12 Oct 2016

To: Faro Mine Site - Yukon Government

Mitigation of Flicker on Meters at IWTP

Fig.1

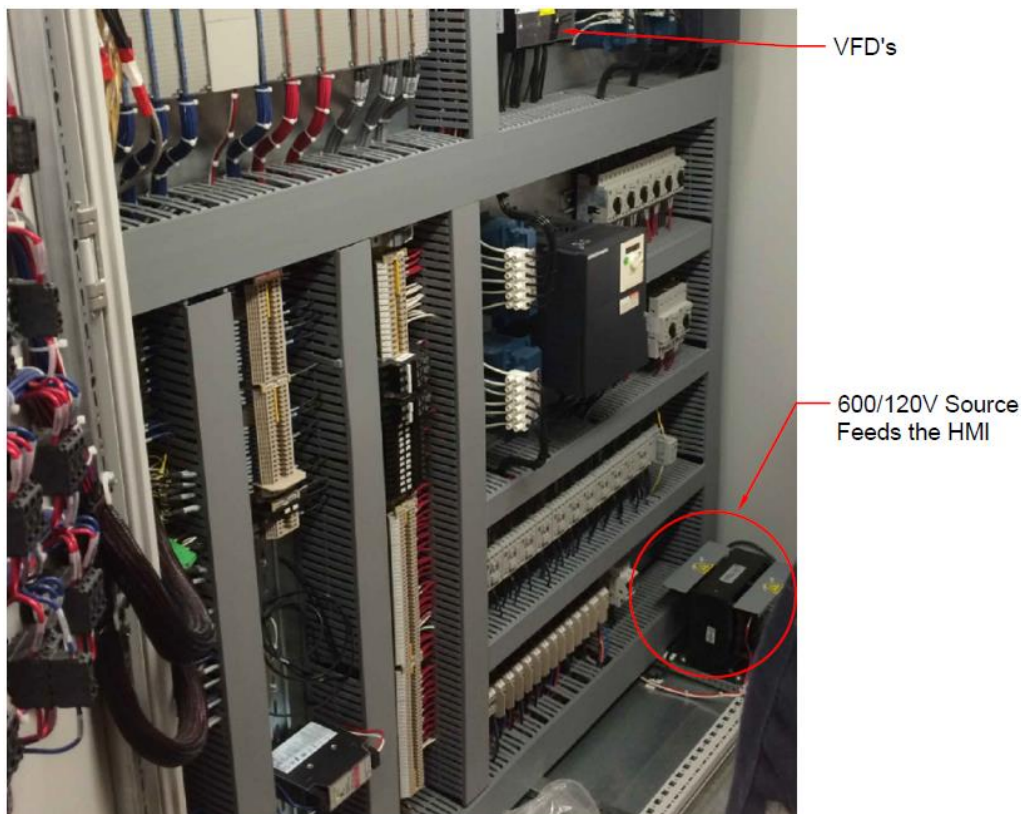
System information displayed on the HMI for the Flow meter, PH and Turbidity readings at the IWTP was observed to flicker continuously. We suspected the cause of this flicker was intersystem ground noise. This type of noise is most likely caused by the VFD's located in the same enclosure as the power source that feeds the HMI.

The major path for this intersystem coupling to occur is through the metallic surface of the enclosure that electrically connects the "referenced ground point on the negative terminal of the 120V HMI source" to the "VFD earth ground".

To get an idea of the amount of noise generated by the VFD and possibly other noise generating components in the cabinet, we measured the voltage from the metallic surface of the enclosure to an external ground point and observed 10's of mV in the kHz range. This difference in potential is the major cause of the ground loop between the VFD cabinet and the HMI cabinet.

The long term solution is to bring in a reference point to the -120V terminal that is away from the noise generated by the VFD. To do this we recommend following the steps outlined below:

- a) De-energize the cabinet shown in figure 1.
- b) Using the same gauge of wire coming out of the 120V terminals in the cabinet, run a wire from a grounding point outside the building to the cabinet. (There are many points to do this near the 2MVA - 25kV/600V transformer).

- c) Connect an insulated terminal block inside the cabinet where the HMI 120V source resides.
- d) Connect the grounded wire from the exterior of the building to this terminal block.
- e) Remove all wires connected to the -120V terminal and reconnect just the white “-120V” wire that feeds the 120V circuit to the insulated terminal block from part “c”.
- f) Connect a single wire from the -120V terminal to the insulated terminal block.
- g) Ensure all terminals on the insulated terminal block are shorted together and isolated from the housing.
- h) Re-energize the cabinet and observe the flicker on the PH meters.
- i) If the problem persists, try different grounding points outside the building.
